PROJECT: Summerlin Village 95 Parcel E

CITY OF LAS VEGAS		DATE:
INTER-OFFICE MEMORANDUM		November 2, 2020
TO: Land Development Services Department of Building & Safety		FROM: Albert Sung, P.E. Flood Control Project Engineer Department of Public Works
SUBJECT:	Drainage Study for:	COPIES TO:
Summerlin Village 25 Parcel E		RCI Engineering
Cross Streets:	SEC of Fox Hill Drive & Redpoint Drive	Lennar Communities Nevada LLC
File Number:	F:\Depot\DSMemos\DS5374A.doc	Bart Anderson, P.E., DevCo
Parcel Number:	137-27-511-001	
Zoning Action:	TMP-78668	
FEMA Flood Zone	YES NO X	
Proposed Storm Drain	YES X NO

The Drainage Study for the subject project has been reviewed and:

Worksheet for SECTION D 41-FOOT 100-YEAR

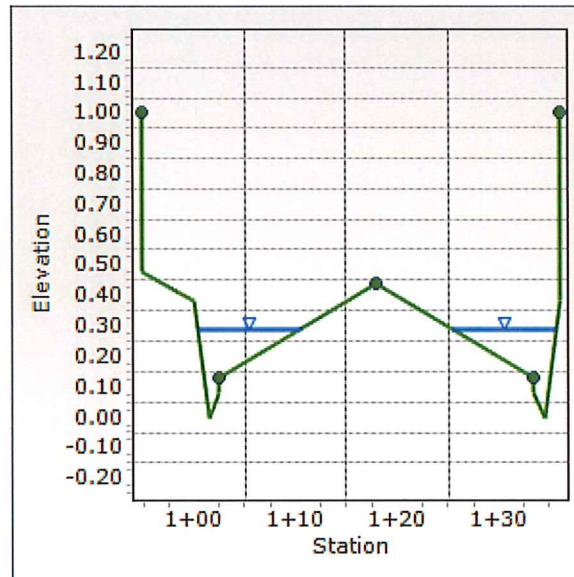
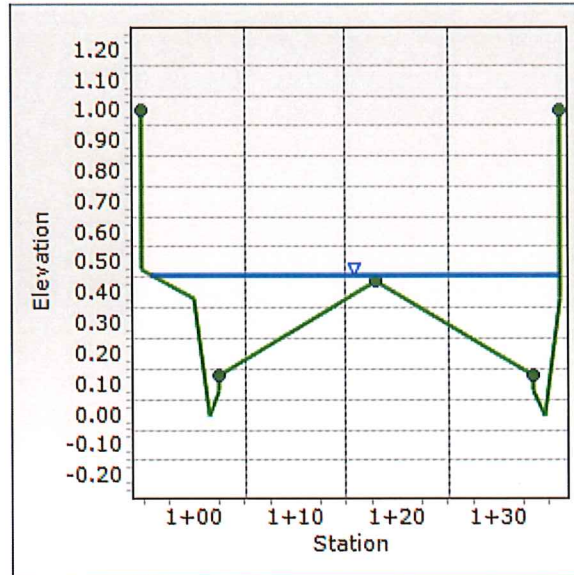
- Per Hydraulic Sections D & E, the 100-year flow depth is 0.46' and 0.58' which will flow over the top of the roll curb along Lots 17 to 26. Revise to limit the 100-year flow depth to the top of curb.

FIGURE 6
ULTIMATE CONDITION BASIN MAP

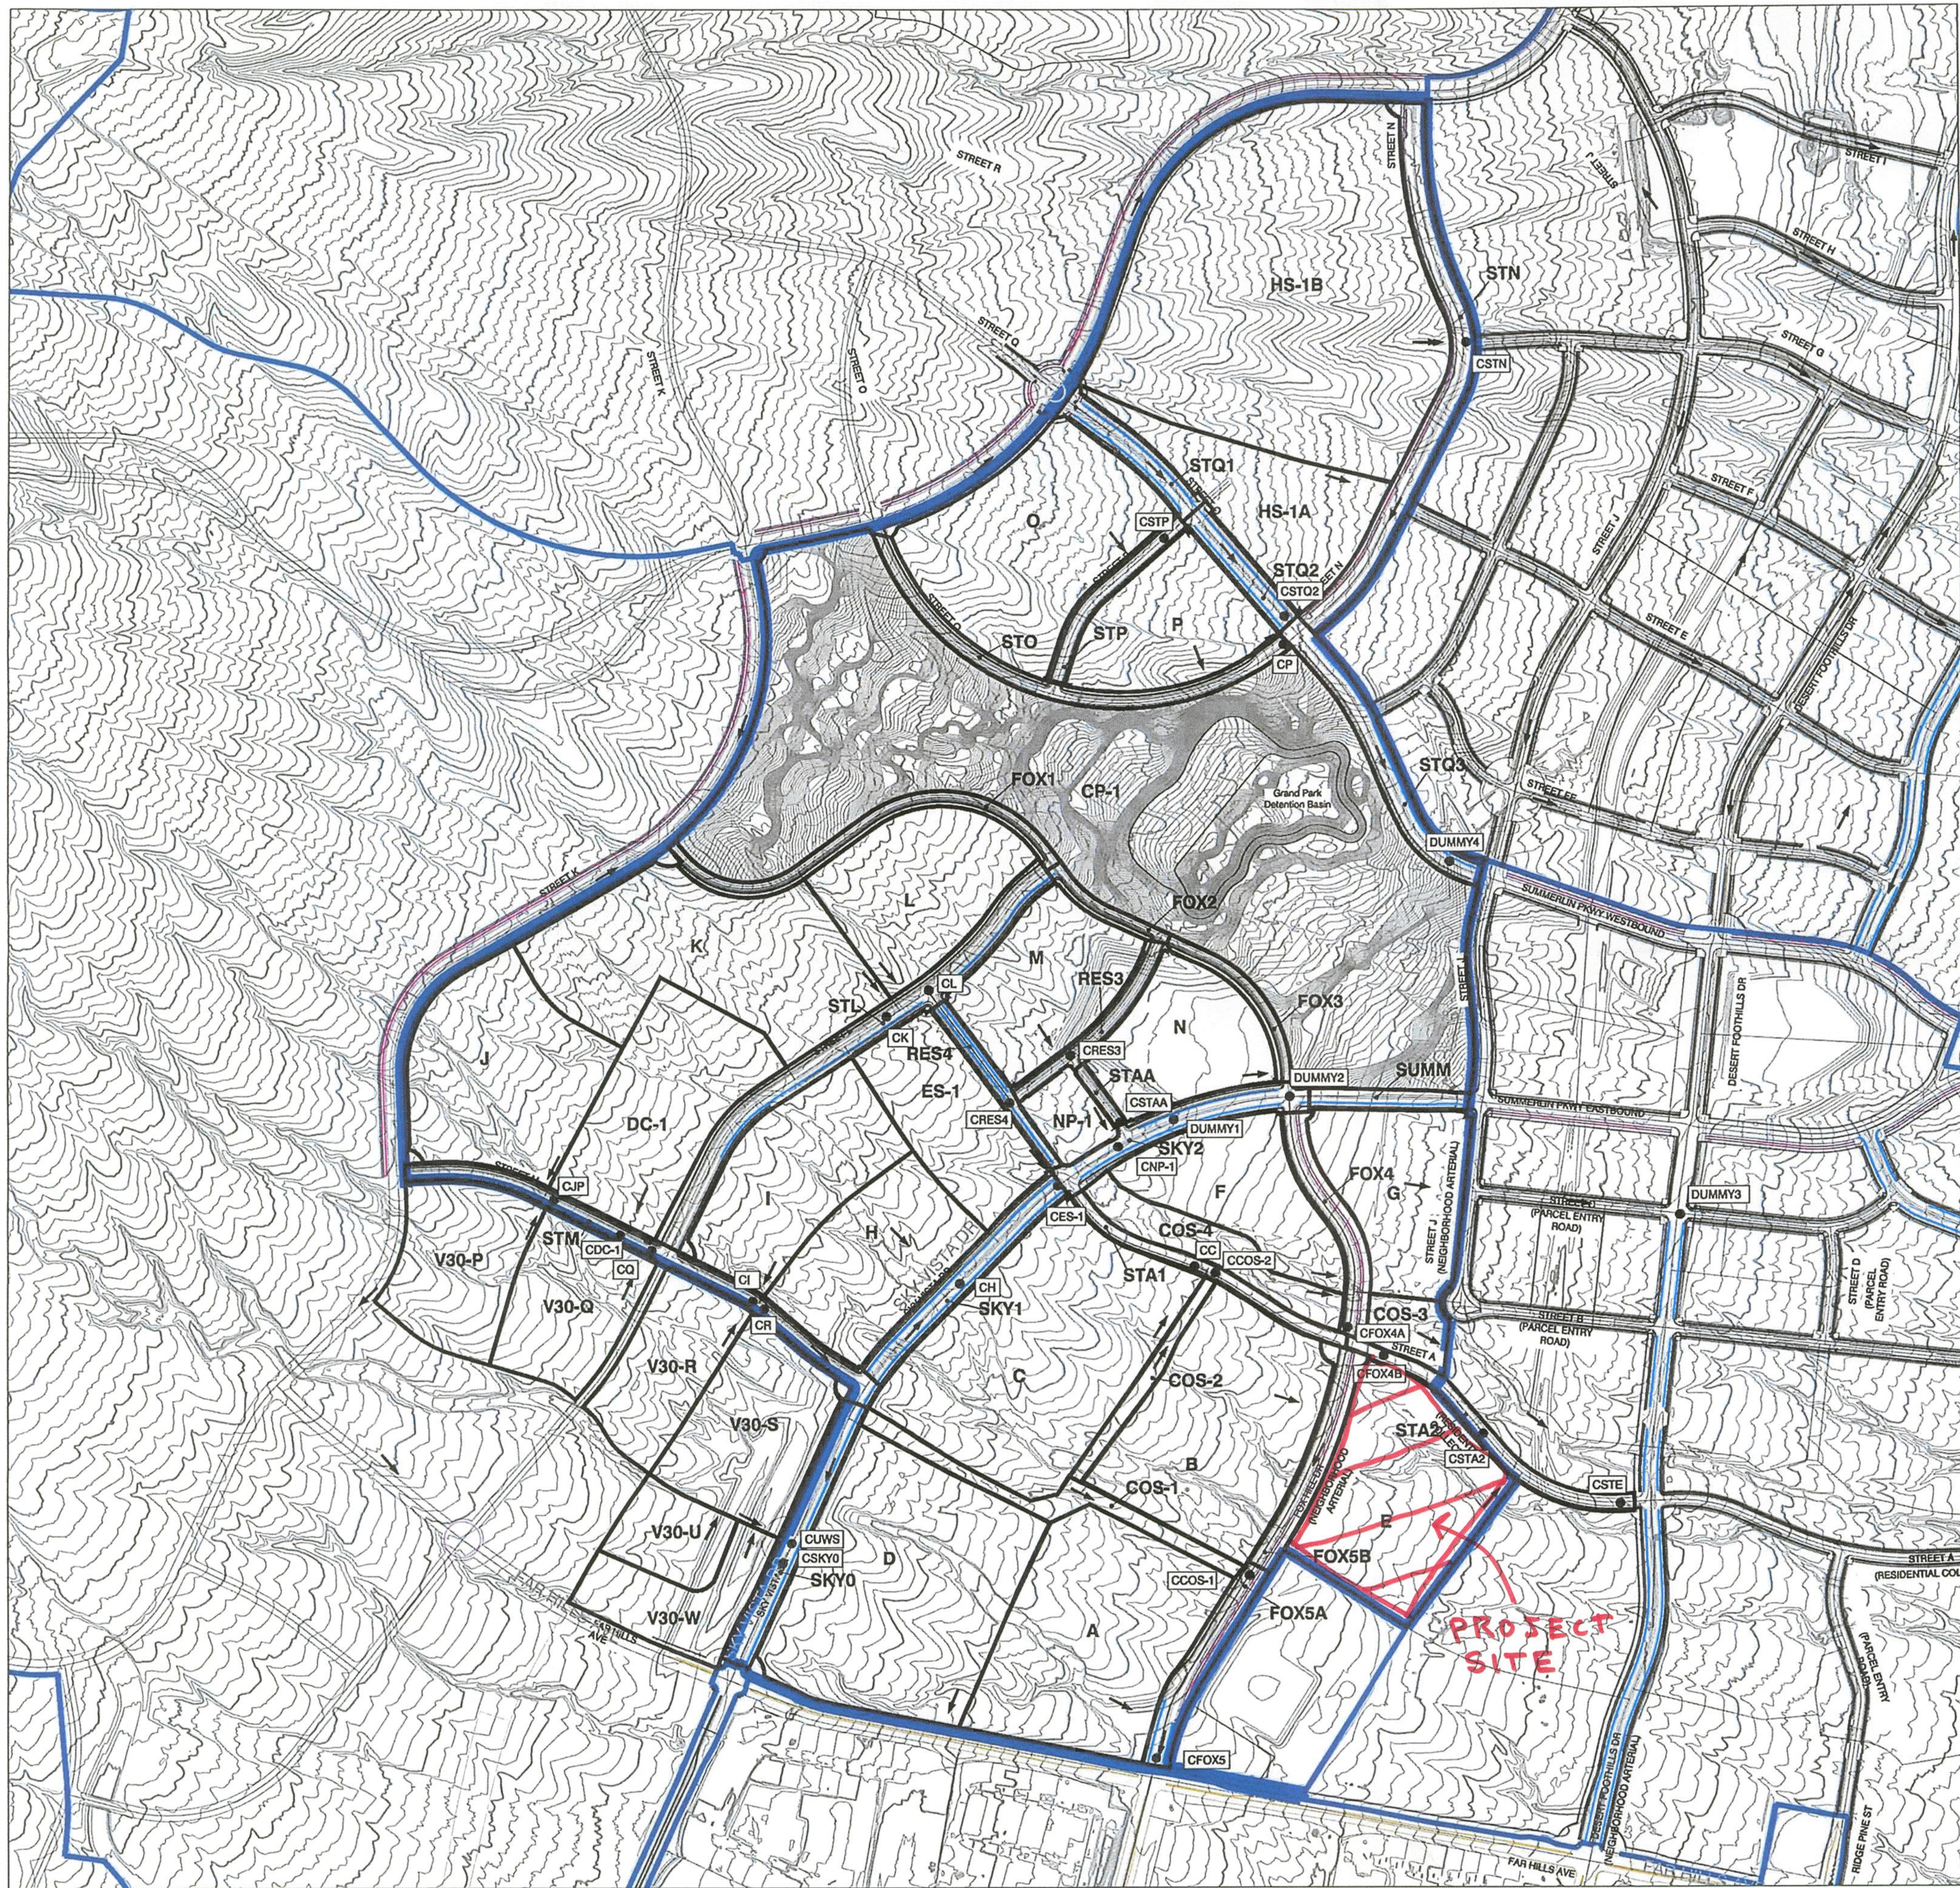
- The *Study* referenced the *Ultimate Conditions Drainage Map* as Figure 5. However, it appears that the *Ultimate Conditions Map* provided is **Figure 6**. Review and clarify or provide Figure 5 in the next submittal.

- Cross Section 21 on Lot 3 shows that it is on sheet D-1 but is on sheet D-2. Review and revise accordingly.
- Show the Flow Depth and Velocity values from Appendix C for the adjacent streets *Redpoint Drive* and *Fox Hill Drive* on **Figure 6**.

IMPROVEMENT PLANS FOR
SUMMERLIN VILLAGE 25 PARCEL E
A SINGLE FAMILY RESIDENTIAL SUBDIVISION
GRADING PLAN (SHEET 1 OF 5)

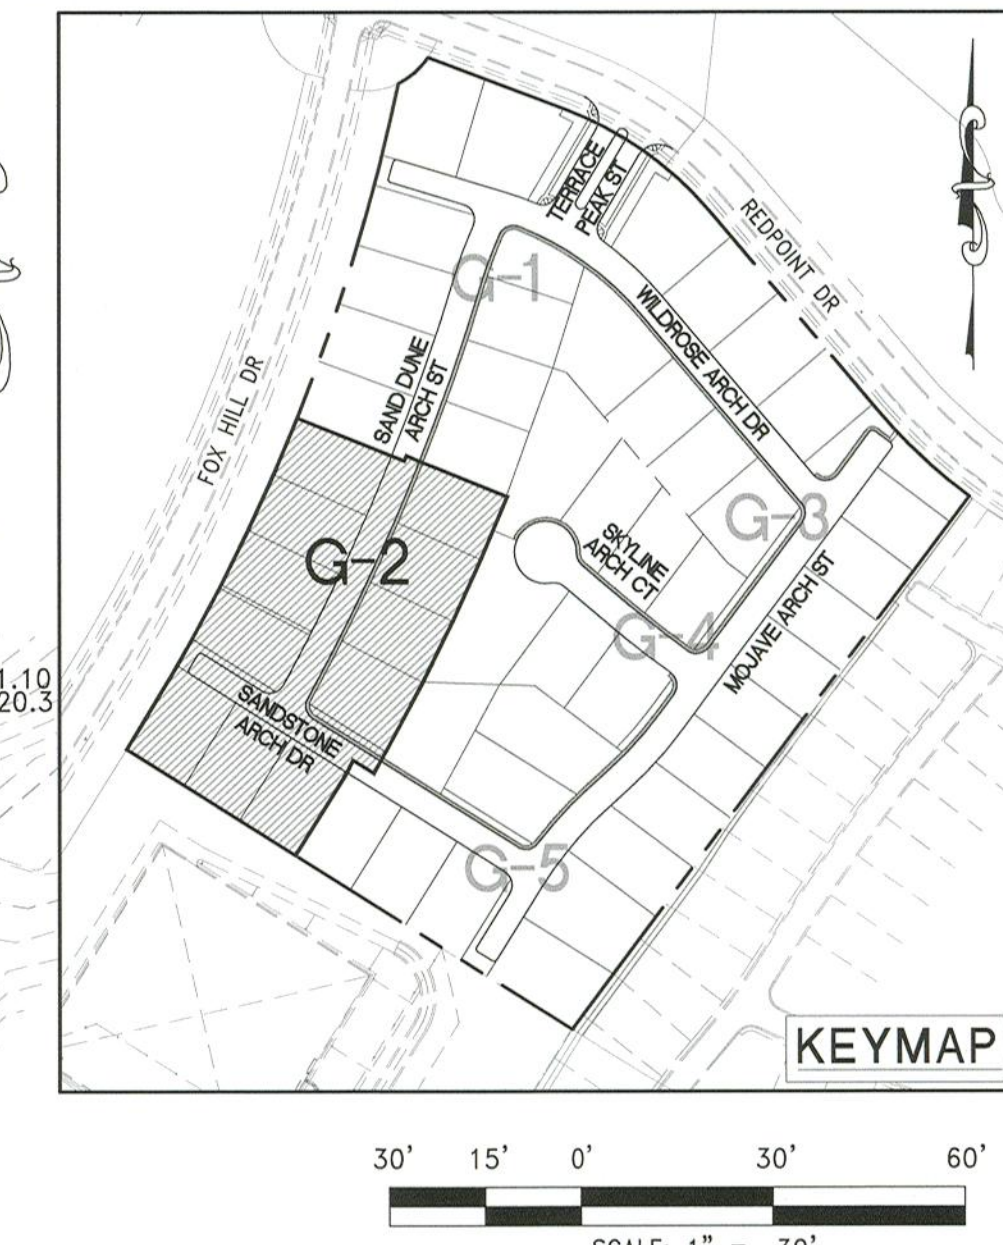
7. **Sheet G-1:** The west side of the *Entry Driveway* to *Redpoint Drive* does not provide adequate freeboard to the 100-year flow depth in *Redpoint Drive*. Note that the hump must provide a minimum of six inches (6") of freeboard. The east side of the entry way meets the criteria though. Review and resolve in the next submittal.

IMPROVEMENT PLANS FOR
SUMMERLIN VILLAGE 25 PARCEL E
A SINGLE FAMILY RESIDENTIAL SUBDIVISION
GRADING PLAN (SHEET 3 OF 5)

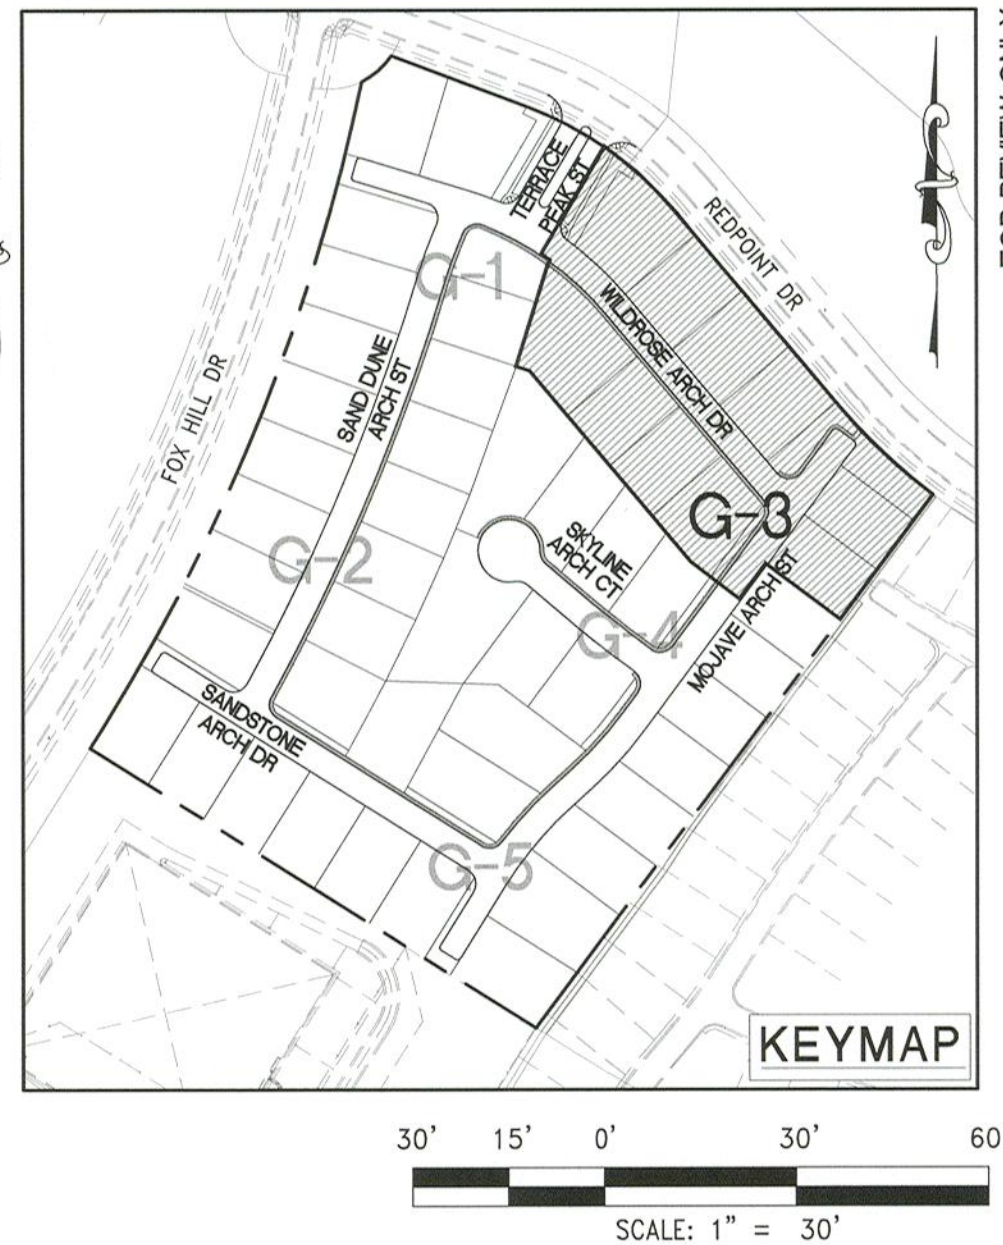
8. **Sheet G-3:** Per the grading design, it appears that drainage on the east side in *Mojave Arch Street* will make two 90-degree turns to the proposed DI #1 on the west side of the street. This will create turbulence and inefficient capture of surface flows at the cul-de-sac. Provide one inlet either at the east side of *Mojave Arch Street* or at the far end curb to improve the flow condition.

9. **Sheet G-3:** It appears that there is a contour line 3402 in the drainage easement which will act as a dam causing a potential ponding depth of about 1.6' in case the proposed inlet is totally clogged. Note that the maximum ponding depth is six inches above the top of curb. Provide enough grade elevation changes to verify the criterion will be met.

10. **Sheet G-3:** It appears that the existing 43.94' public drainage and sewer easement does not align with the storm drain at the end of *Mojave Arch Street*. The engineer may consider vacate the existing drainage easement and re-dedicate the easement. The recordation of the new easement must be done prior to the final approval of the improvement plans.

11. **Sheet G-3 to Sheet G-5:** Label the existing finished floor elevation of the adjacent houses to the east in the *Summerlin Village 21 Parcel F* developments.
